Item Name: Crosstube Aft

DART AEROSPACE LTD		Work Order:	87297
Description: Crosstube High Aft (412)		Part Number:	D412-664-203
Inspection Dwg: D412-664-243	Rev: E	Page 1 of 1

DRAWING NO. D412-664-243	TITLE CROSSTUBE ASSEMBLY (412 HI AFT)	REV. E	DART AEROSPACE LTD ENGINEERING ORDER		D.E.O. NO. D412-664-243-E-1	SHEET NO. SHEET 1 OF 2	SCALE NTS	
DRAWN	CHECKED	MFG. APPR.	APPROVED	DE APPR.				
DATE 11.03.31	DATE 11/03/31	DATE 11.03.31	DATE 11/03/31	DATE 11.03.31

DRAWING NO. D412-664-243	TITLE CROSSTUBE ASS'Y (412 HI AFT)	REV. E	<b>DART AEROSPACE LTD ENGINEERING ORDER</b>		D.E.O. NO. D412-664-243-E-2	SHEET NO. SHEET 1 OF 1	SCALE NTS
DRAWN <i>q</i>	CHECKED <i>ASS</i>	MFG. APPR. <i>RE</i>	APPROVED <i>MP</i>		DE APPR. <i>#</i>		
DATE 11.09.07	DATE 11.09.19	DATE 11.09.19	DATE 11.09.19		DATE 11.09.19

**D412-664-243  
ASSEMBLY DETAIL**

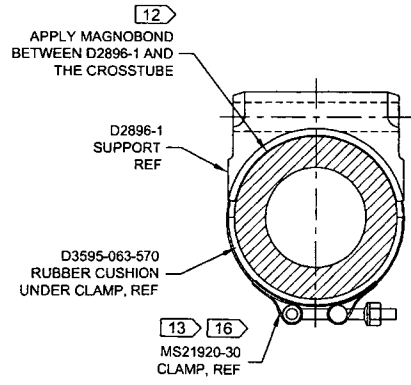
**PURPOSE:**

REMOVED ABRASION STRIP IN FAVOR OF A THIN LAYER OF PROSEAL 890.

**CHANGE:**

**IS:**

D3189-1 CHAFING SHIELD (1, INSTALLED OVER PROSEAL 890)  
MS21920-28 CLAMP, 2X  
2 PL

**WAS:**

D2856-600-1009 ABRASION STRIP  
D3189-1 CHAFING SHIELD (1, INSTALLED OVER ABRASION STRIP)  
MS21920-28 CLAMP, 2X  
2 PL

2  
MASK AREA PRIOR TO PAINTING AND  
APPLY CLEAR COAT AFTER PAINTING

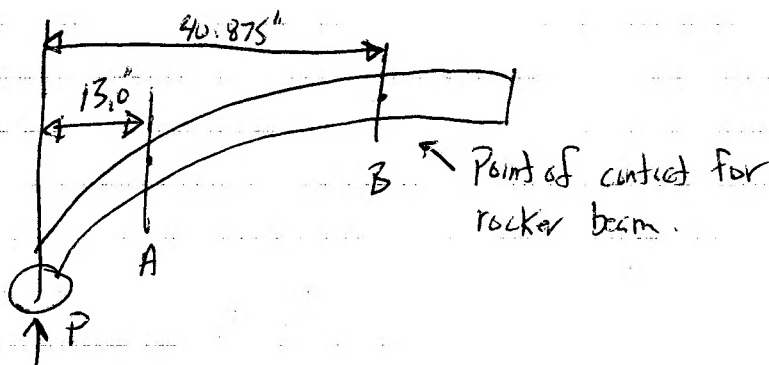
**PURPOSE:**

REPLACE MAGNOBOND WITH 3M DP460 SCOTCH-WELD EPOXY ADHESIVE

NOTE 12 & 16, SHEET 1 IS AMENDED AS FOLLOWS:

- 12) INSTALL D2896-1 CENTER SUPPORT USING A 0.04" TO 0.07" THICK LAYER OF SCOTCH-WELD DP460 PER QSI 015. LET CURE FOR 24 HOURS AFTER INSTALLATION AND PRIOR TO PACKAGING.
- 16) TORQUE CLAMPS 80 TO 100 IN-LB. ENSURE AT LEAST 1.5 THREADS SHOWING IN SAFETY AND THAT NUT HAS NOT BOTTOMED-OUT AFTER TORQUING. **PRIOR TO PACKAGING, RE-CHECK TORQUE ON CLAMPS AFTER ADHESIVE HAS CURED FOR 24 HOURS.**
